CATEGORY: Recommended for Plant Implementation.

Summary: CarnaudMetalbox recommend the following component upgrade to increase the service life of the air strip valve. **(Part number UMV-5469)**

For further information regarding this Technical Bulletin please contact either of the contacts below quoting Technical Bulletin Number **TB5000-061** and your machine Serial Number

Fig. 2
Aluminium Diaphragm Holder

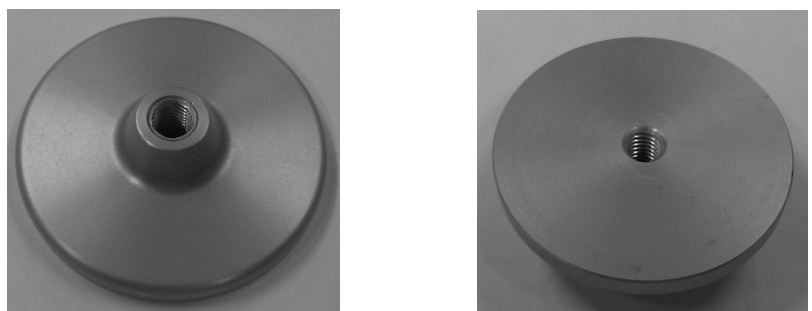
As a result of customer feedback CarnaudMetalBox Engineering recommend the replacement of the plastic diaphragm holder with an improved aluminium design.

The plastic diaphragm holder consists of a plastic body with a steel threaded insert. However, prolonged periods of continuous operation have resulted in the gradual fatigue of the plastic diaphragm holder. This has resulted in the appearance of cracks with the component eventually separating into many parts. **See Fig. 1**

After investigation by CarnaudMetalBox engineers and in collaboration with the air valve suppliers the plastic diaphragm holder has been replaced with an aluminium diaphragm holder which will increase durability and extend service life. **See Fig. 2**

A spares kit **(Part Number UMV-5686)** is available from CarnaudMetalBox Engineering to refurbish existing air strip valves to the latest standard.

From **February 2012** onwards all new air strip valves purchased from CarnaudMetalBox Engineering will include the new aluminium diaphragm holder as standard.
